Fire Sprinkler System Survey Report

8 Burnham Street
Petone

Date: 28 September 2022
Survey No: 23665
Site Ref: A1928
Issue: A

Conclusions

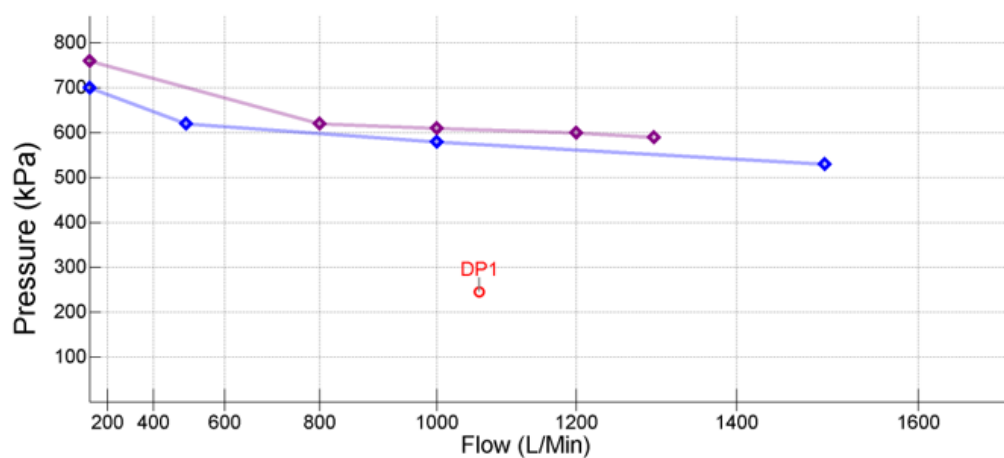
We could not ascertain the design demands for the Extra Light Hazard office spaces and Niche Modules rear metal work warehouse, therefore we cannot confirm the adequacy of the water supply for these areas.
